LICENSE AUTHORITY FILE COPY  
UNITED STATES  
NUCLEAR REGULATORY COMMISSION  
WASHINGTON, D. C. 20555

The Commission has issued the enclosed Amendments Nos. 119, 119, and 116 to Licenses Nos. DPR-38, DPR-47 and DPR-55 for the Oconee Nuclear Station, Units Nos. 1, 2 and 3. These amendments consist of changes to the Station's common Technical Specifications (TSS) in response to your request dated November 12, 1982, as supplemented on February 24, 1983.

These amendments revise the TSS concerning the heatup, cooldown and inservice test limitations for the reactor coolant systems of each Oconee unit.

SAFETY EVALUATION BY THE OFFICE OF NUCLEAR REACTOR REGULATION

Figure 3.1.2-1A

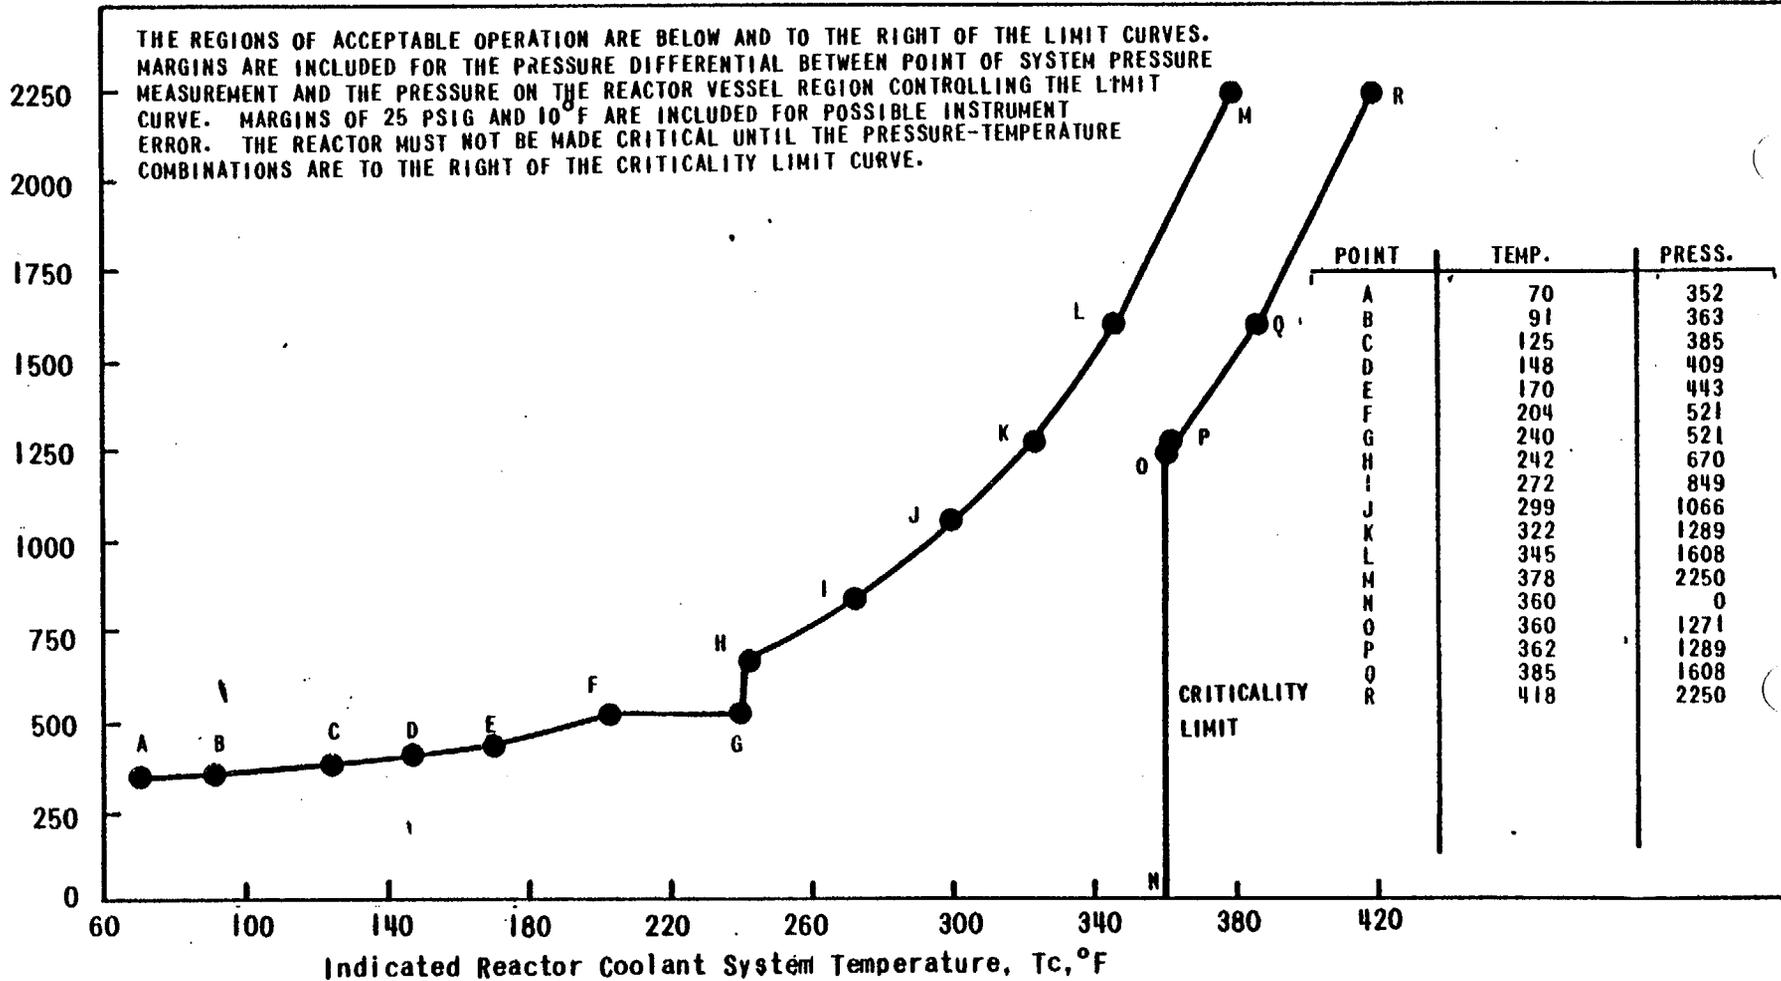
UNIT 1 OCONEE NUCLEAR STATION  
 REACTOR COOLANT SYSTEM NORMAL OPERATION-HEATUP  
 LIMITATIONS APPLICABLE FOR THE FIRST 15 EPY

Heatup rates and allowable combinations of pressure and temperature shall be limited in accordance with Table 3.1-1 and Figure

3.1.2-1A Unit 1

Figure 3.1.2-1B

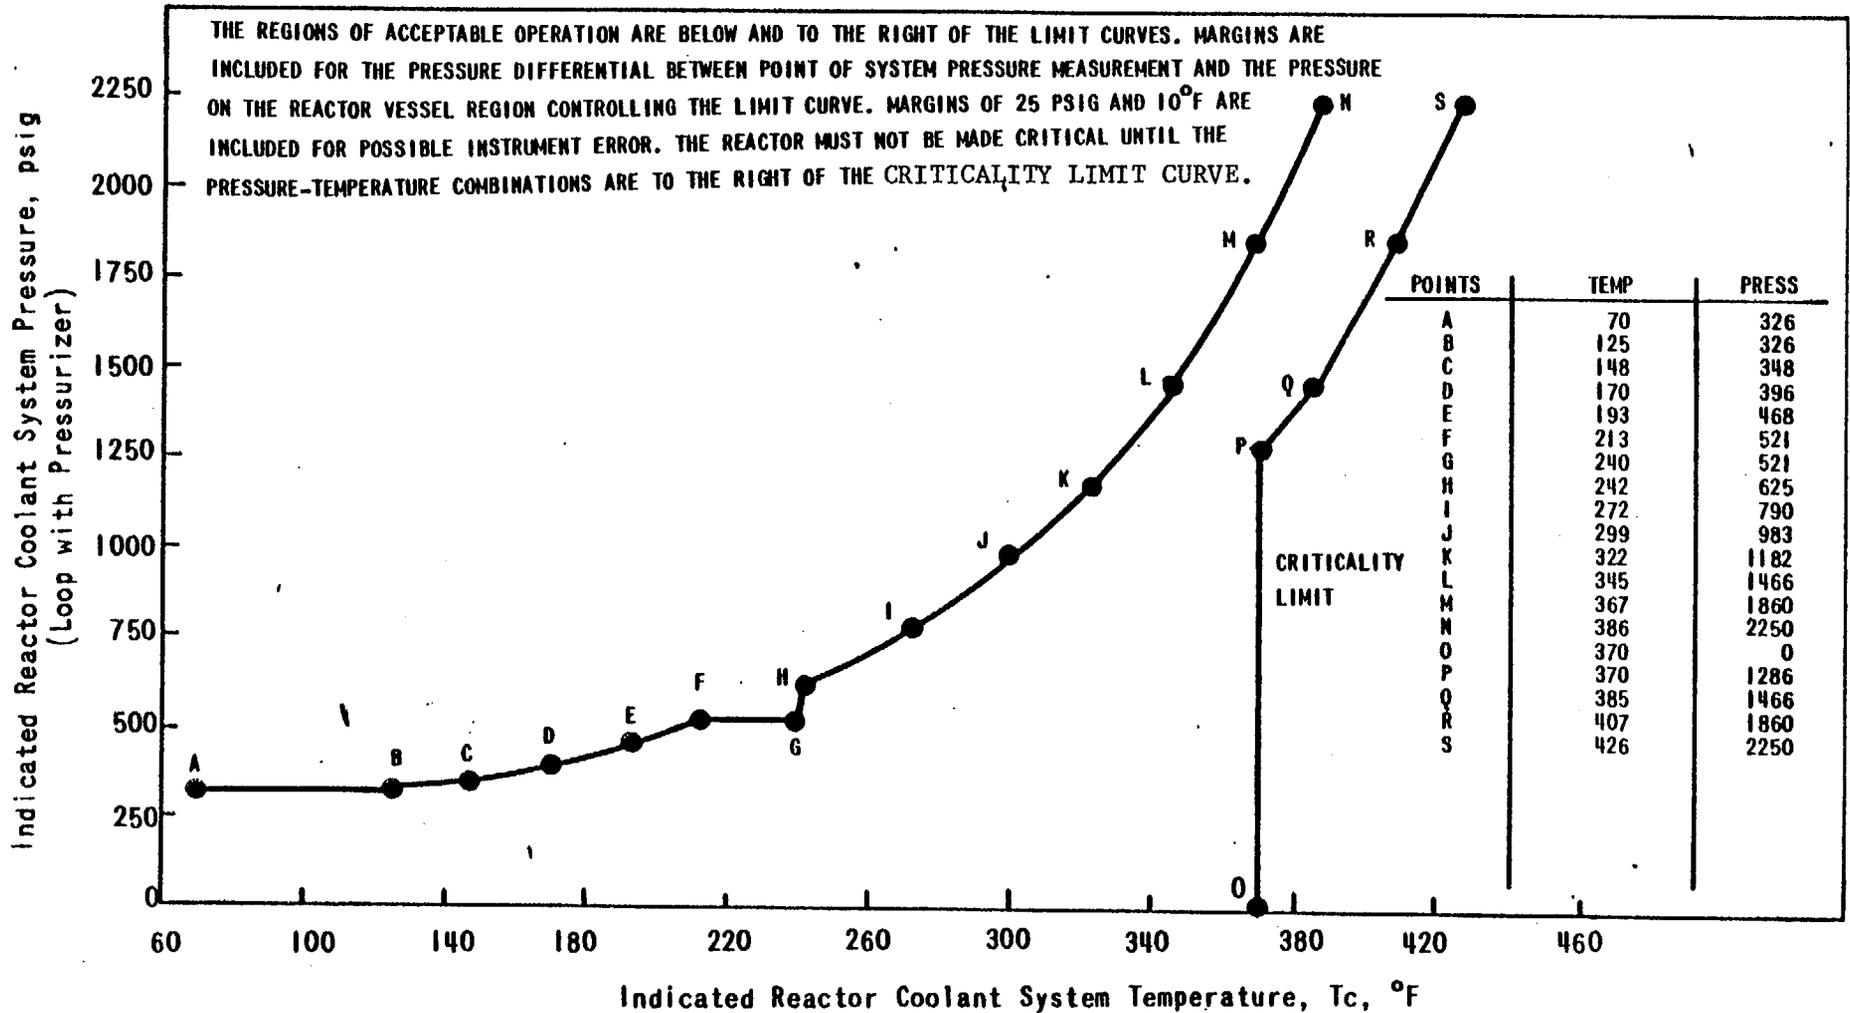
UNIT 2 OCONEE NUCLEAR STATION  
REACTOR COOLANT SYSTEM NORMAL OPERATION-  
HEATUP LIMITATIONS APPLICABLE FOR FIRST 15.0 EFY

3.1.2-1B Unit 2

Figure 3.1.2-1C

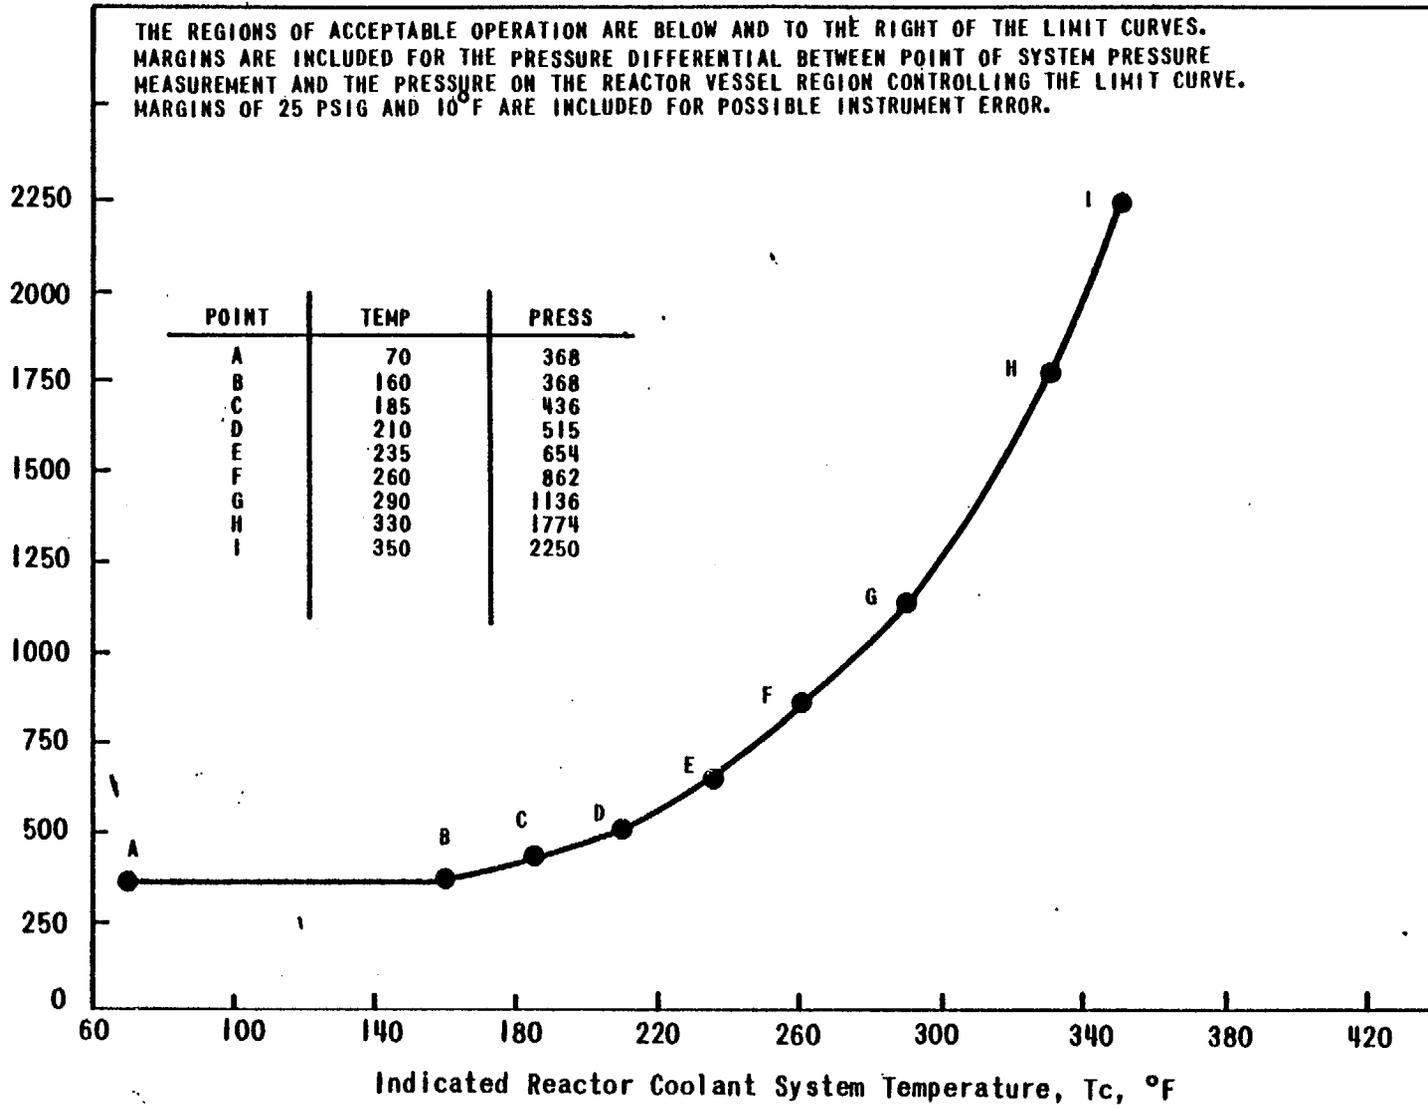
UNIT 3 OCONEE NUCLEAR STATION  
 REACTOR COOLANT SYSTEM NORMAL OPERATION-HEATUP  
 LIMITATIONS APPLICABLE FOR FIRST 15.0 EFPY

3.1.2-1C Unit 3

Figure 3.1.2-2A

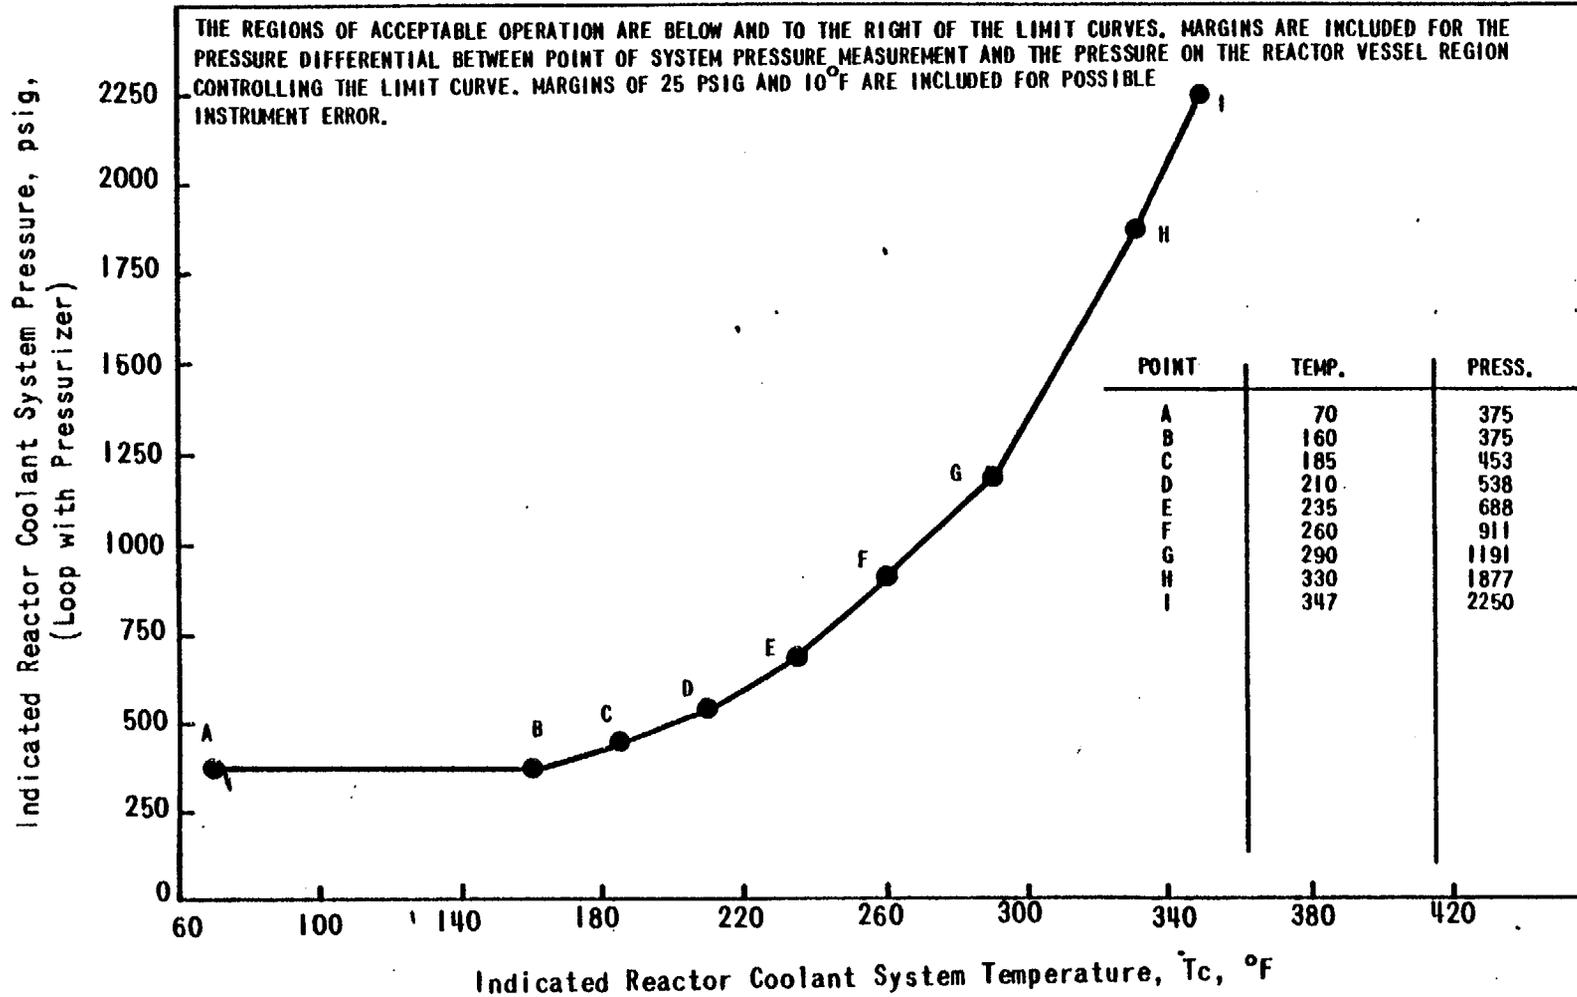
UNIT 1 OCONEE NUCLEAR STATION  
REACTOR COOLANT SYSTEM NORMAL OPERATION-  
COOLDOWN LIMITATIONS APPLICABLE FOR  
FIRST 15 EFPY

Cooldown rates and allowable combinations of pressure and temperature shall be limited in accordance with Table 3.1-2 and Figure

3.1.2-2A Unit 1

Figure 3.1.2-2B

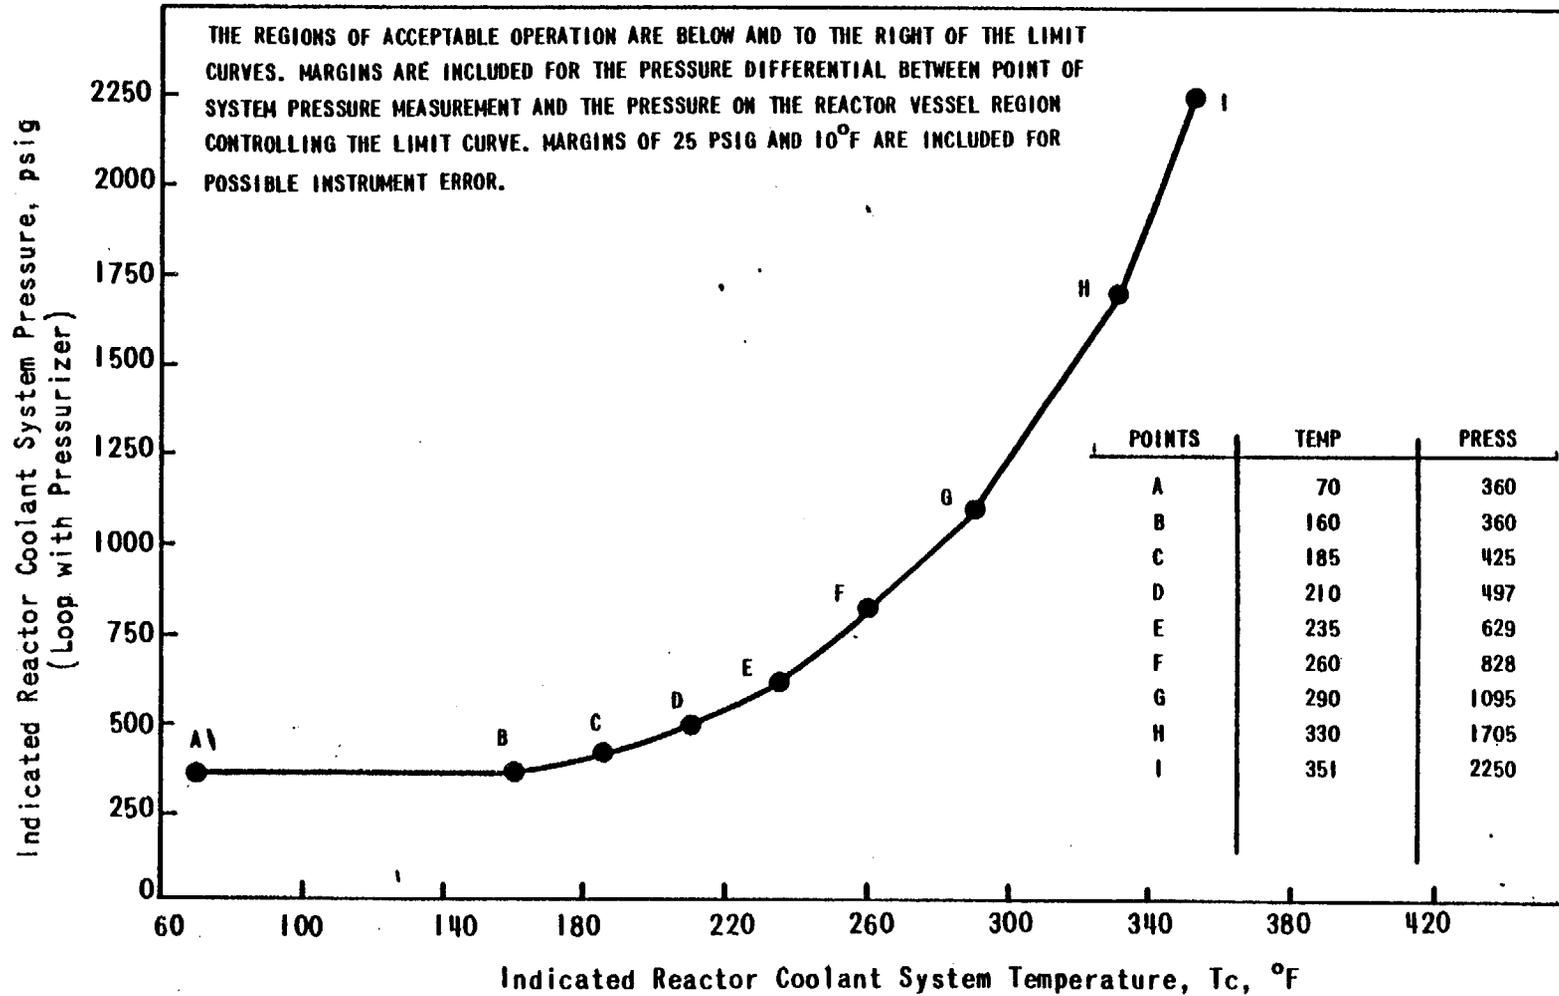
UNIT 2 OCONEE NUCLEAR STATION  
 REACTOR COOLANT SYSTEM NORMAL OPERATION-COOLDOWN  
 LIMITATIONS APPLICABLE FOR FIRST 15.0 EFPY

3.1.2-2B Unit 2

Figure 3.1.2-2C

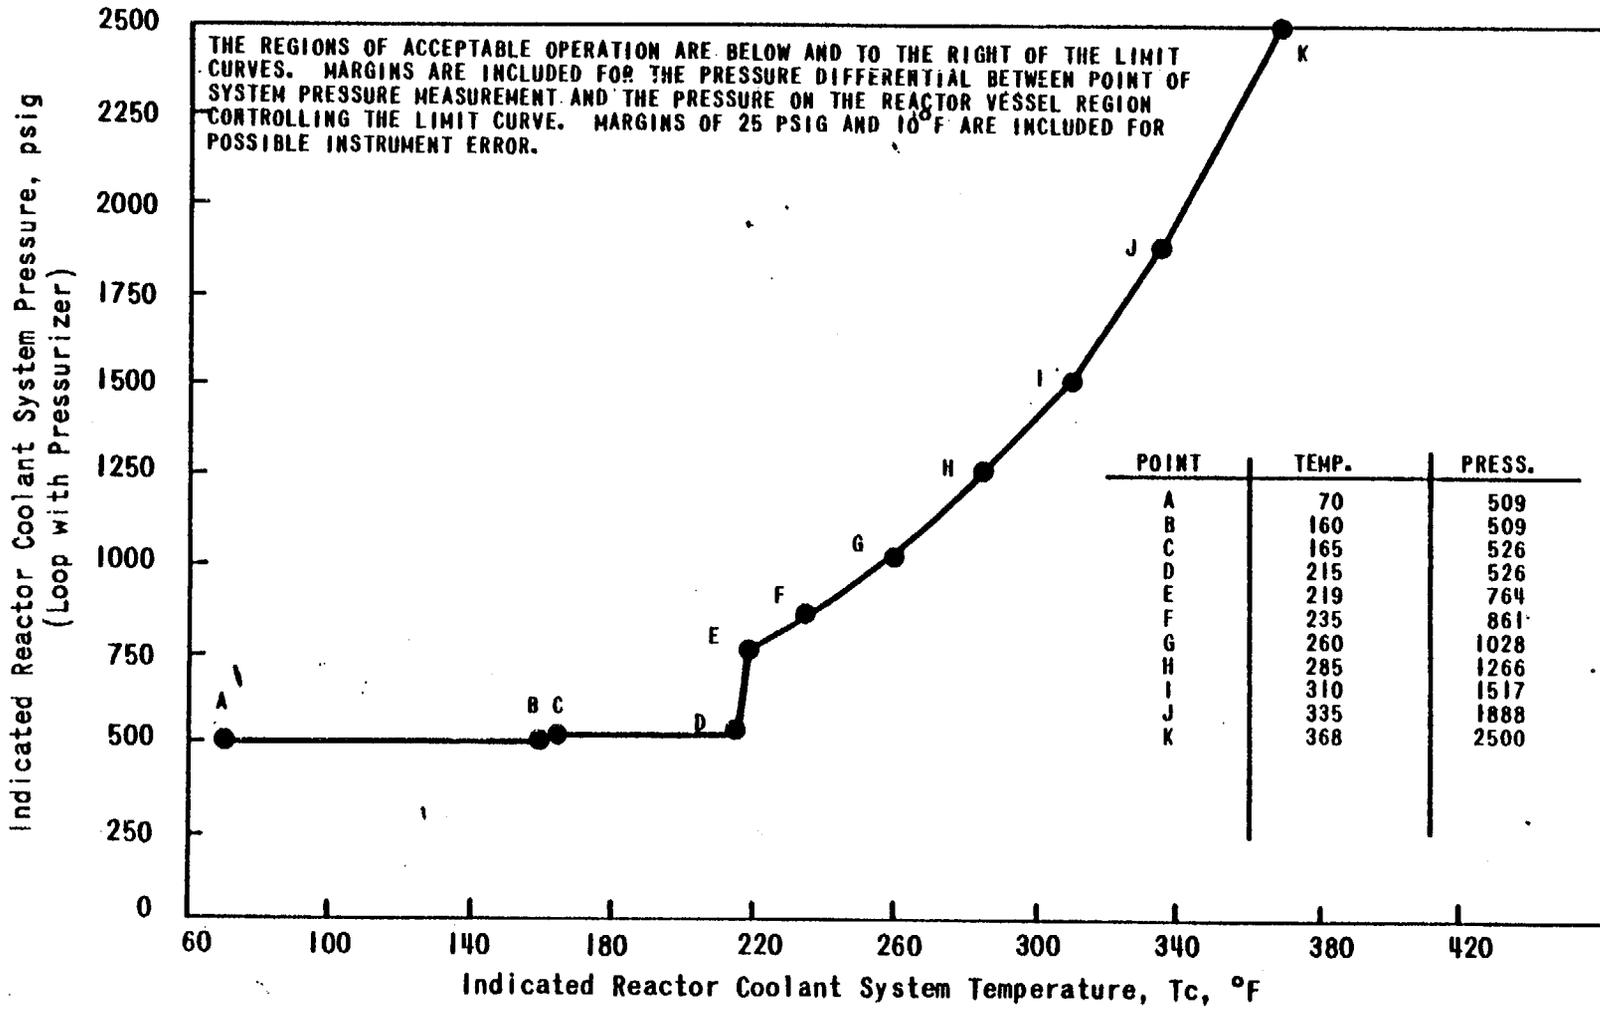
UNIT 3 OCONEE NUCLEAR STATION  
 REACTOR COOLANT SYSTEM NORMAL OPERATION-COOLDOWN  
 LIMITATIONS APPLICABLE FOR FIRST 15.0 EFY

3.1.2-2C Unit 3
